## ADDENDUM NO.2

**PROJECT:** Cumru Fire Department  
**ADDRESS:** 1775 Welsh Road  
Mohnton, PA 19540

**MWS PROJECT NO:** 18-036  
**DATE:** 1/5/2024

DRAWING	FIRST FLOOR PLAN - HVAC PIPING
SHEET	M201

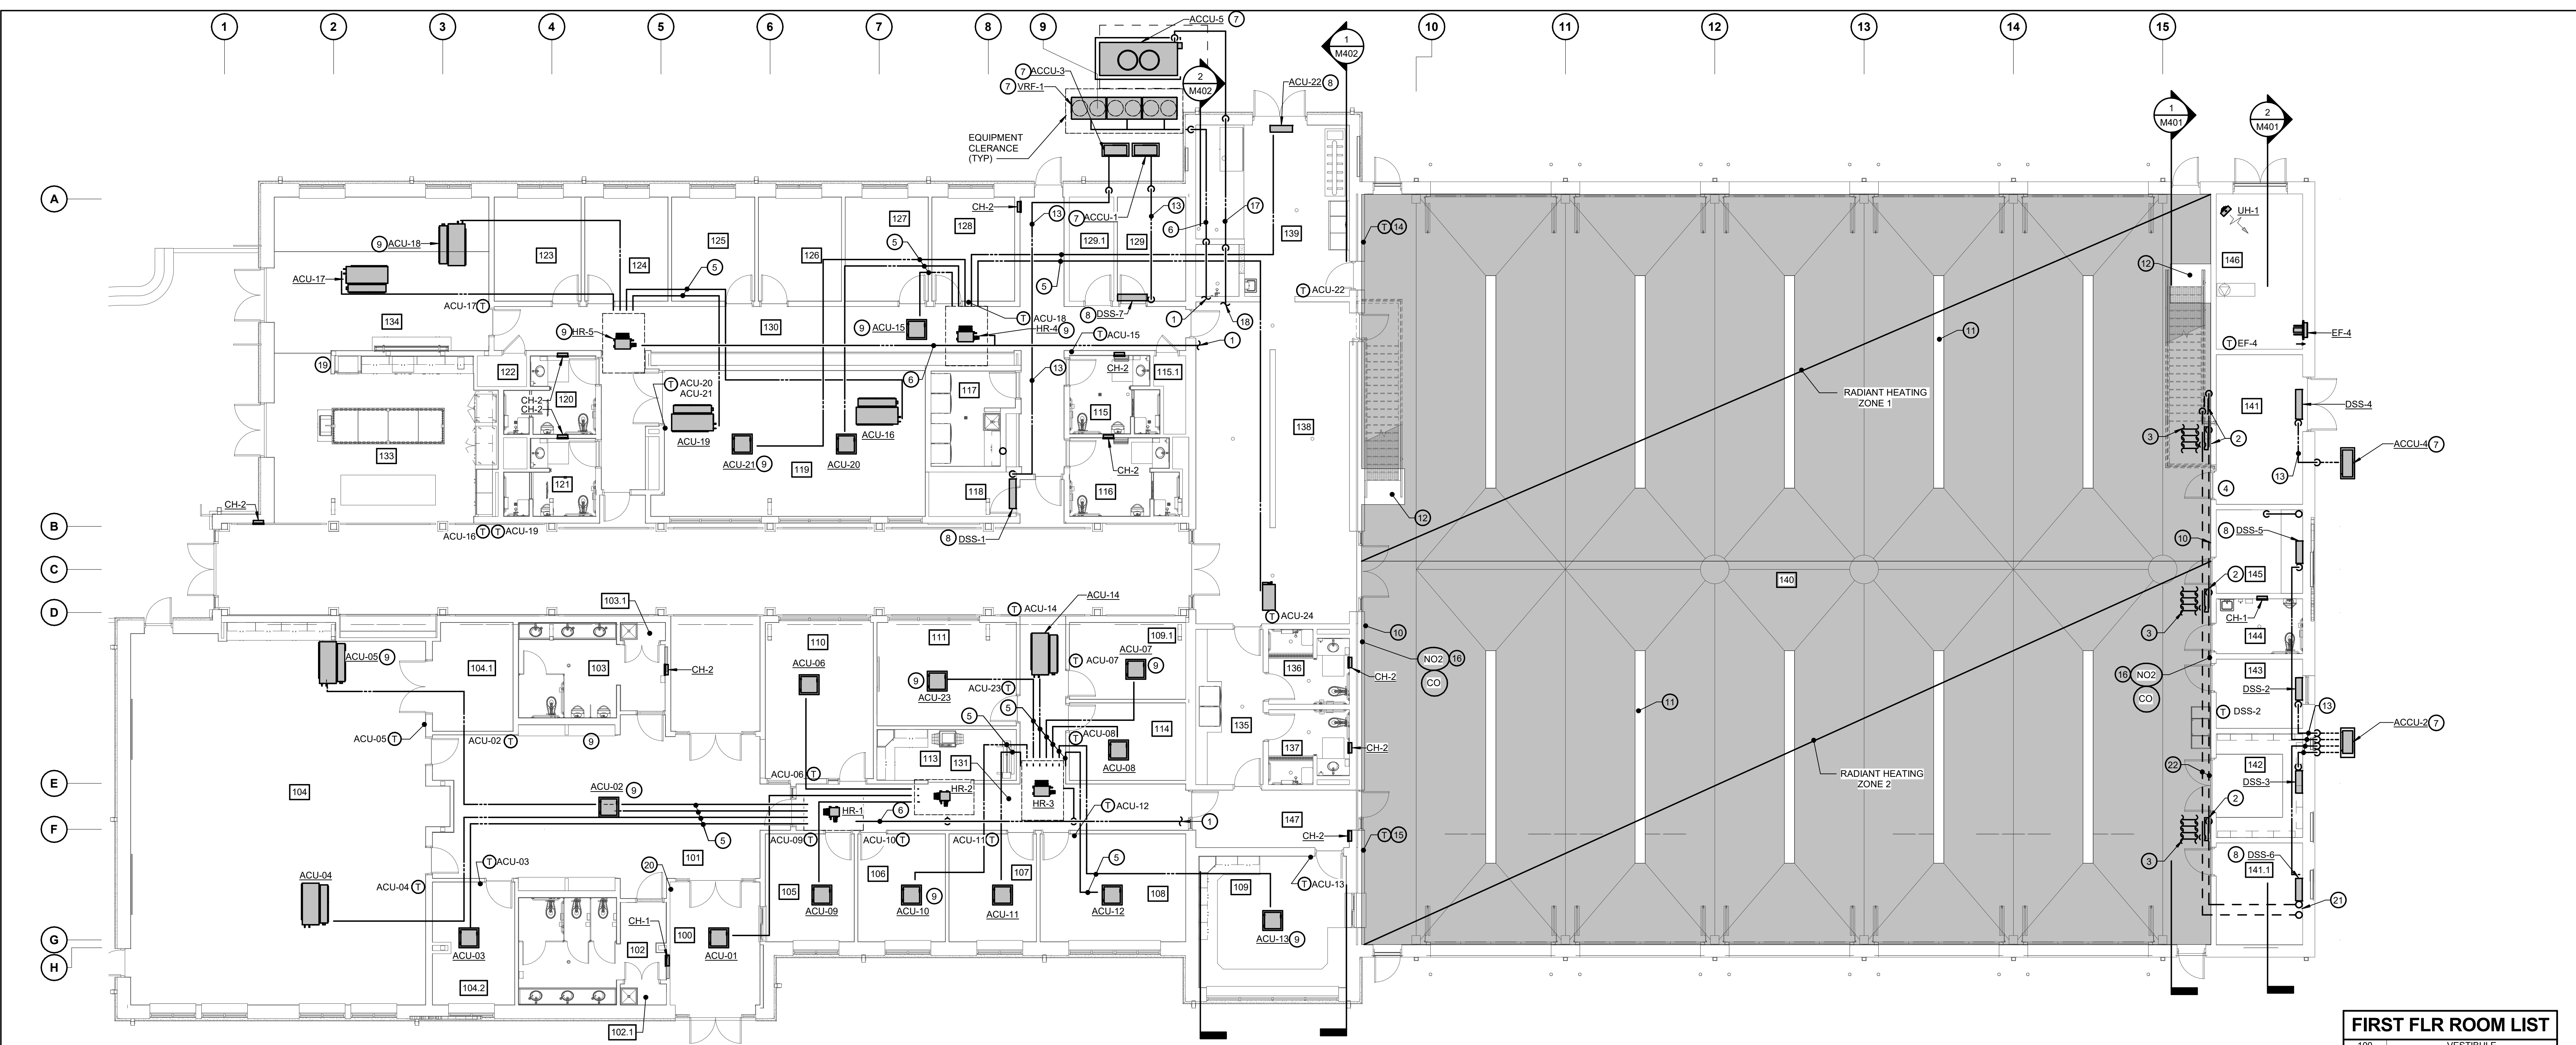
- 1.) **QUESTION:** On mechanical bid set drawing M-201 references heating piping schematic 1 on M-302. M-302 is not in the bid set. Can you get this out in an addendum?

**RESPONSE:** The note on M-201 will be revised to reference heating water piping schematic detail 4 on M-502. Refer to addendum #2 drawings for additional information.

DRAWING	FIRST FLOOR PLAN POWER
SHEET	<b>E101</b>

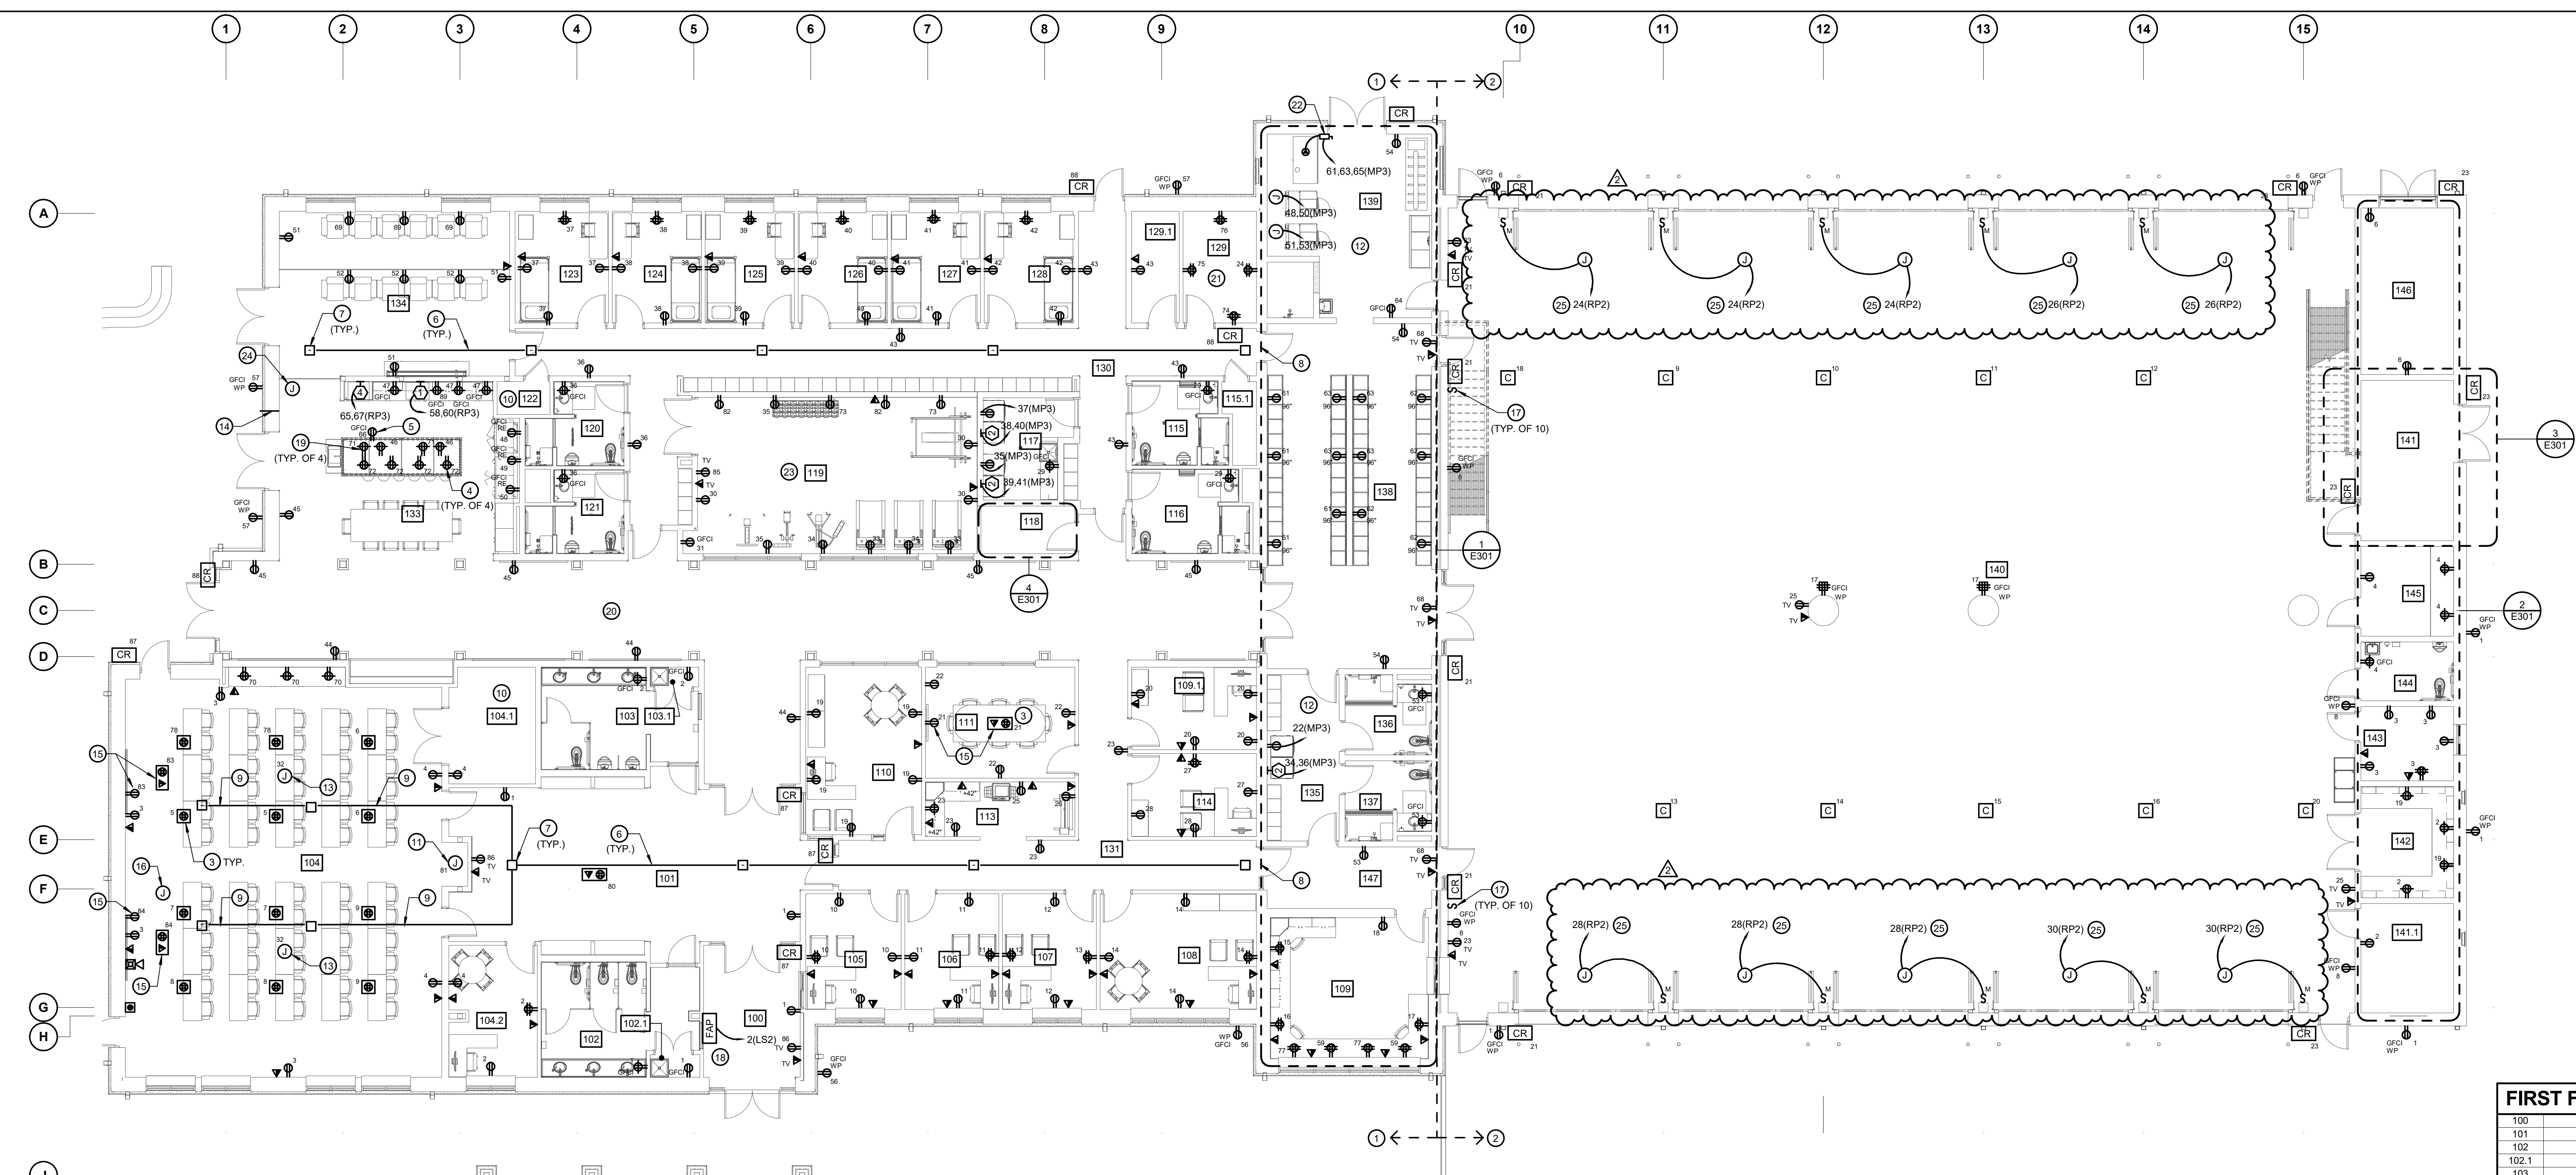
**RESPONSE:** Yes, duplicate safety switch shown on drawing E301 to be removed.
- 26.) **QUESTION:** There doesn't appear to be any power on the electrical drawings for the garage doors.

**RESPONSE:** Power for garage doors shall be provided as shown in Addendum 2.
- 27.) **QUESTION:** Drawing E501 shows the utility transformer secondary conductors by Met-Ed. This is not typical with Met-Ed. Please advise if this is correct.

SHEET  
**E201**

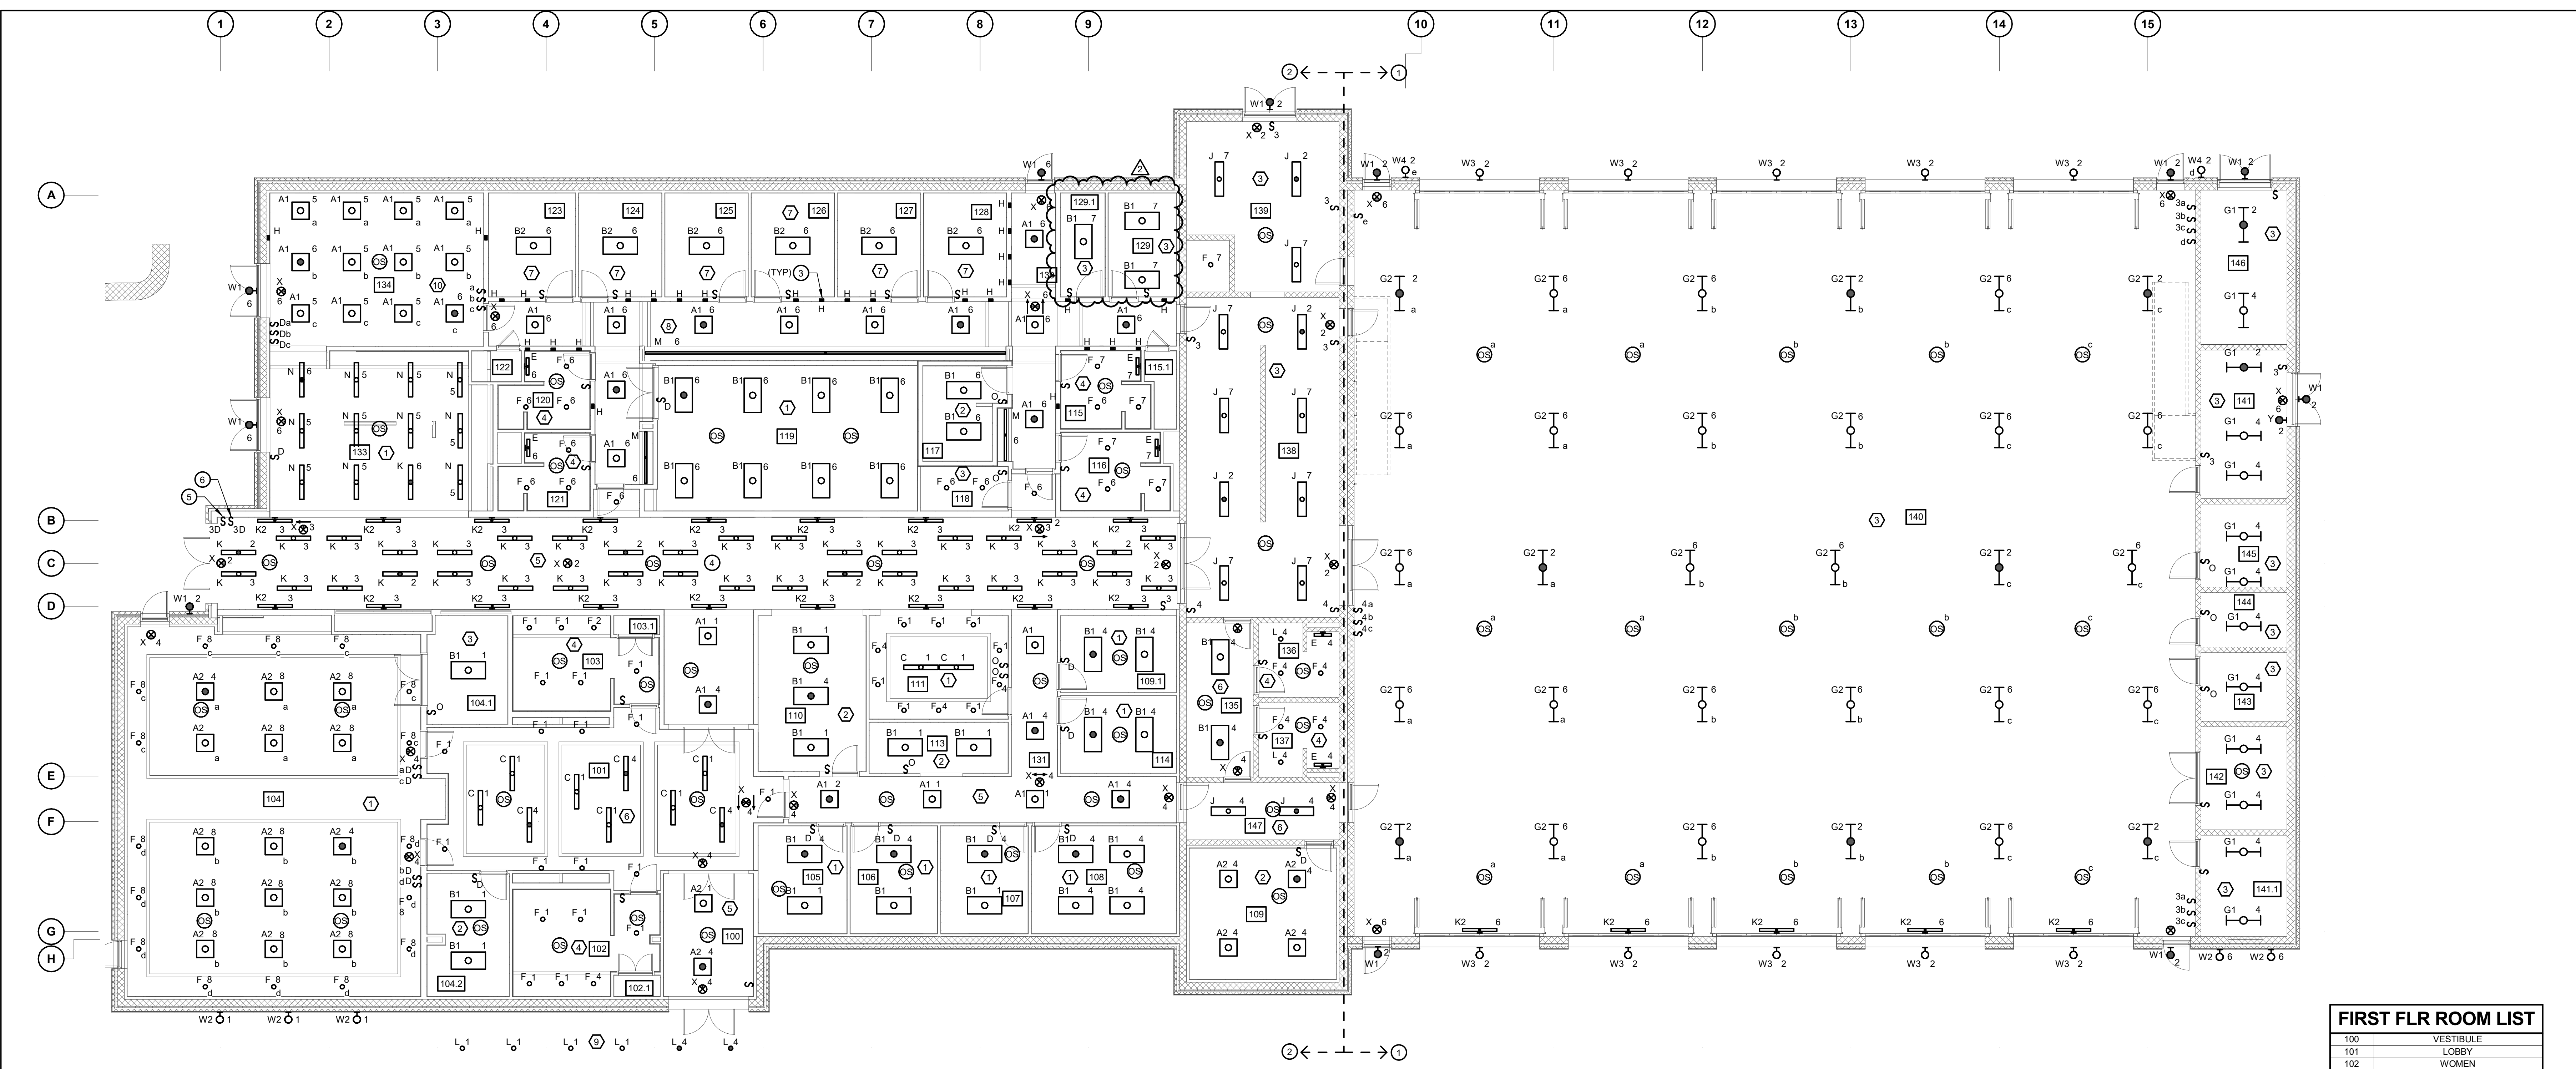
23.) **QUESTION:** There is not a light fixture type shown in room 129.1.

- 24.) **QUESTION:** There is not a light switch shown in room 129.  
**RESPONSE:** Light switch to be provided as shown on Addendum 2.
- 25.) **QUESTION:** There is an 800 amp fused safety switch shown on the exterior wall on drawing E002 that shows a note 5 next to it. There is also an 800 amp fused safety switch shown on drawing E301 that shows a note 11 next to it in the electrical room. Is this a duplicate?

**RESPONSE:** Type B1 light fixture to be provided as shown on Addendum 2.
